# SERVICE BULLETIN

Classification: EM20-005	Reference: NTB20-057	Date: August 10, 2020
-----------------------------	-------------------------	--------------------------

## VK56 CONNECTING ROD CAP BOLT SERVICE INFORMATION

**APPLIED VEHICLES:** 2004–2019 Armada (TA60/Y62)  
 2012–2019 NV (F80)  
 2008-2012 Pathfinder (R51)  
 2004–2019 Titan/Titan XD (A60/A61)

Figure 1

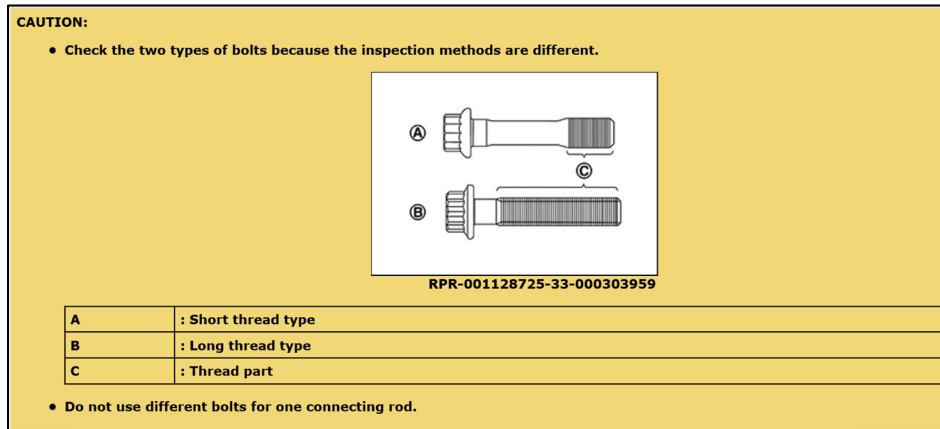
A change has been made to the connecting rod cap bolt service part. The new service part (B in Figure 1) is visually different, but is a direct replacement for the original equipment part.

If replacement of a single connecting rod cap bolt is indicated for any given connecting rod, both connecting rod cap bolts of the affected connecting rod must be replaced as a set.

Figure 2

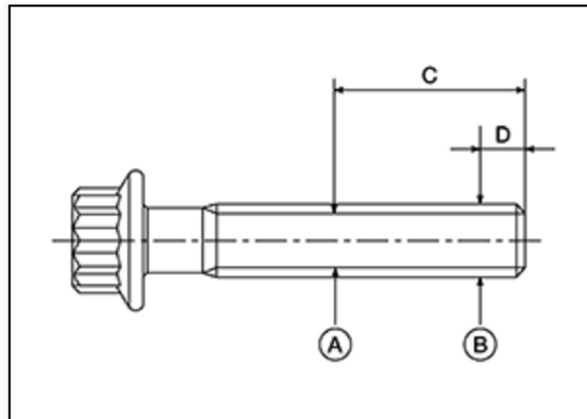
- Measure the outer diameter at location (A) and location (B) shown in Figure 2.

C	: 19 mm (0.75 in)
D	: 5 mm (0.20 in)

- Subtract (A) from (B).  
*Limit [(B) – (A)] : 0.15 mm (0.0059 in)*
- If it exceeds the limit (large difference in dimensions), replace the bolt with a new one.
